City of  
**Peterborough**

## COMMITTEE OF ADJUSTMENT

HEARING DATE: March 23, 2010

### Staff Comments Regarding Files: B1//10, A2/10 & A3/10 B2/10, A3/10& A4/10

# WELLER CRESCENT

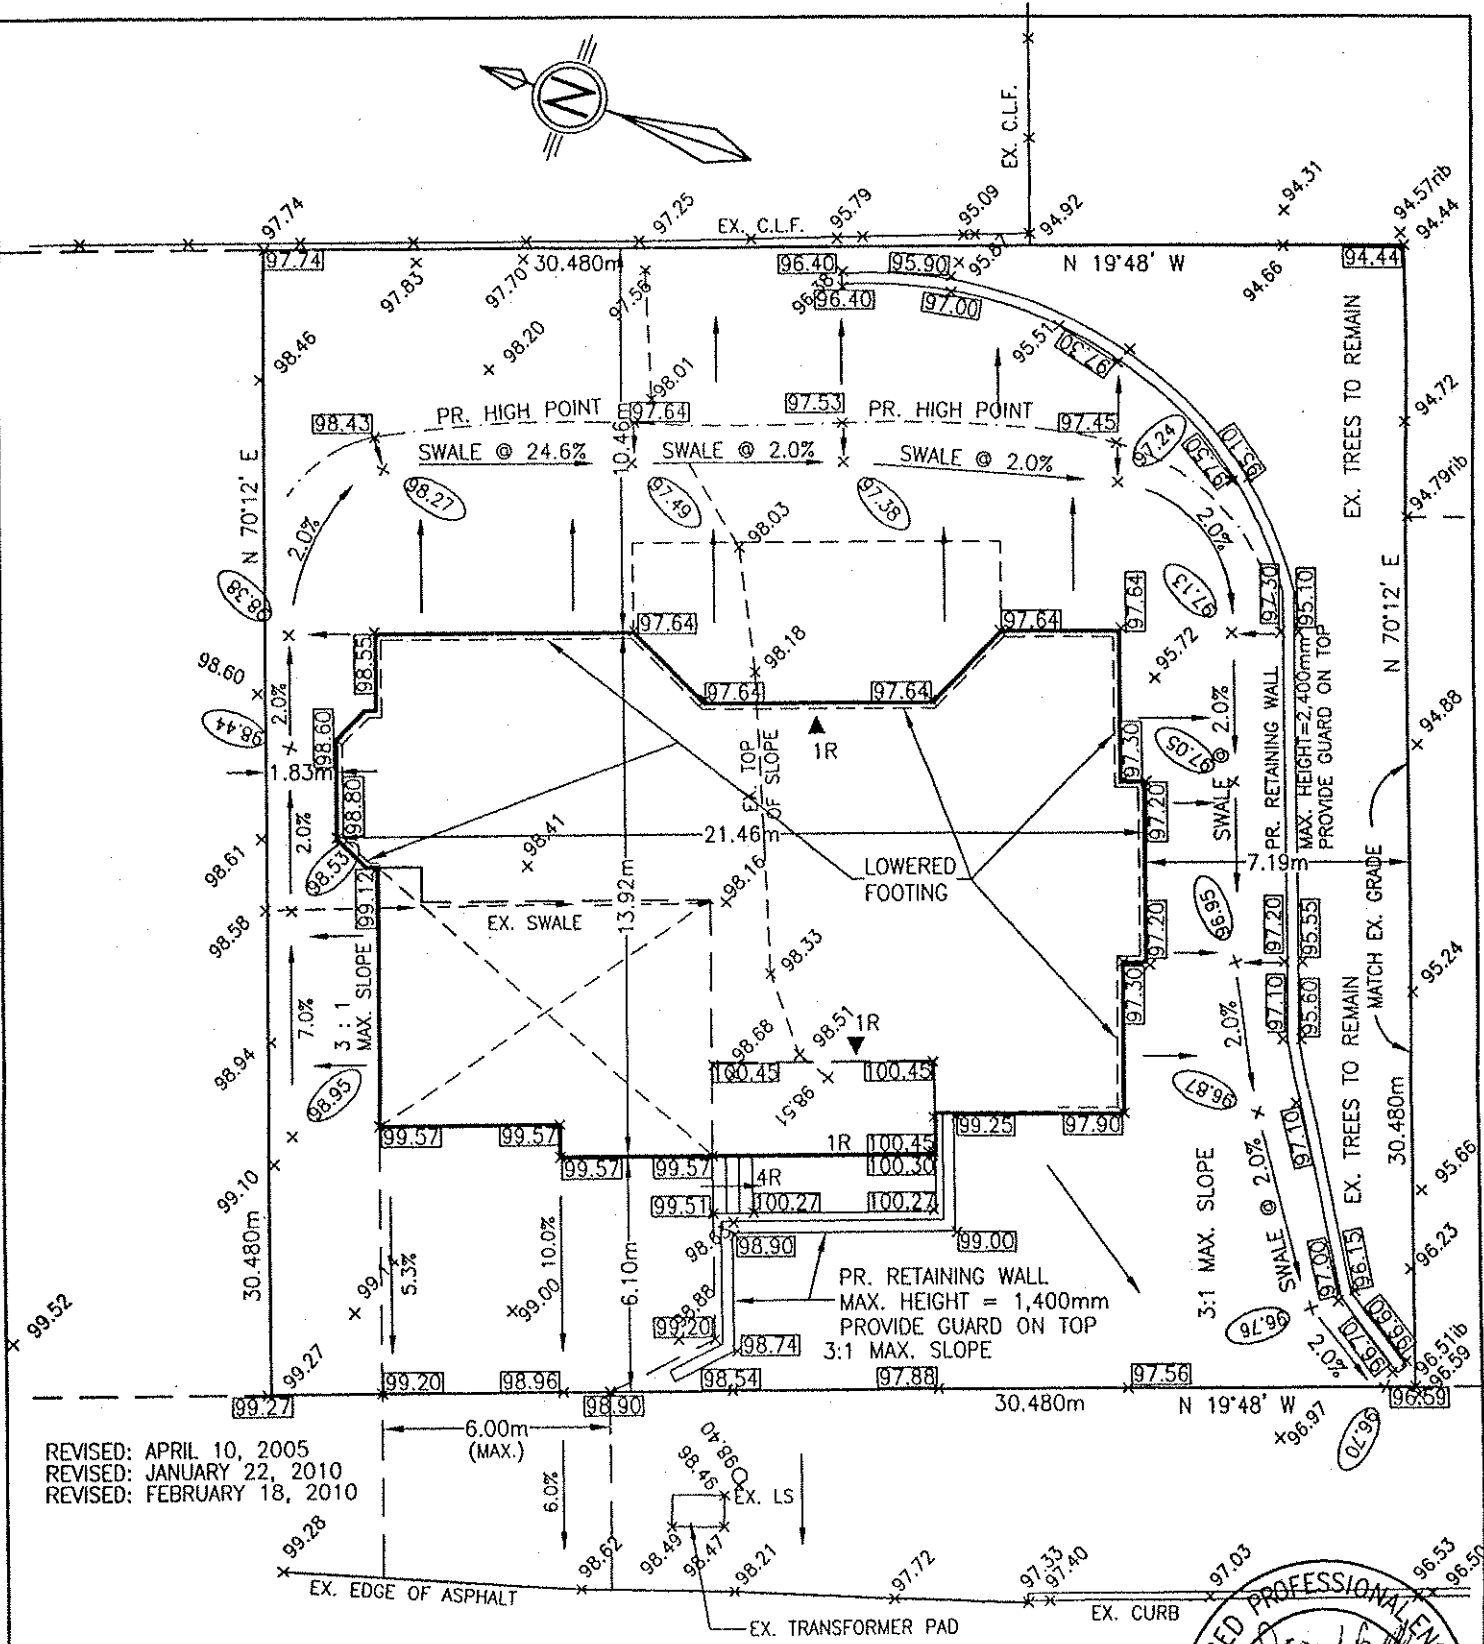
Considering the contours depicting the natural slope of the land, it is apparent that drainage from the subject property is linked to the adjacent properties to the southeast. The revised drainage plan illustrates how drainage of the property could be altered considering the development of the proposed walkout bungalow with the extended elevated deck. The drainage plan will involve re-grading of the property in relation to a 2.2 metre (7 ft) high retaining wall that would be constructed along the south east side of the property. The grading would rely on a swale created to channel most of the water from around the dwelling out toward the street front at the south west corner of the lot.

Staff visited the property and noted that there would inevitably be the need for attention to management of water draining from the property as a result of its development. Staff noted that the lot was well treed and if some of the trees were preserved they could provide a visual screen from the impact of the proposed building location. Considering the size of the proposed dwelling and the proposed re-grading of the lot including the

While an approved grading plan would be required in conjunction with a building permit application for a dwelling that would conform with the zoning of this property, the two variances would result in development closer to the lower side of the lot, leaving less lot area available between the building and lot line to handle the water between the building and adjacent properties. For this reason, staff is concerned with variances being requested that may contribute to the challenge of managing post development drainage from the property without impacting on adjacent lots. While there is no obligation to the owner to deal with sub-surface water issues that may be affecting adjacent properties, excavation and the proposed earthworks on the property will significantly alter the character of this lot and may change the sub-surface water regime affecting adjacent properties.

The latest drainage plan dated February 18, 2010, signed by a Professional Engineer reflects efforts to divert water from adjacent lands. Should the Committee choose to grant the variances, staff would recommend that the owner be required to enter into a development agreement with the City that would require the developer to provide a detailed grading, storm water management, servicing plan together with a plan for the preservation of trees on the property to the satisfaction of the Planner of Urban Design and the City Engineer. The development agreement will require a performance security in the order of \$5000 and final inspection of the development upon completion.
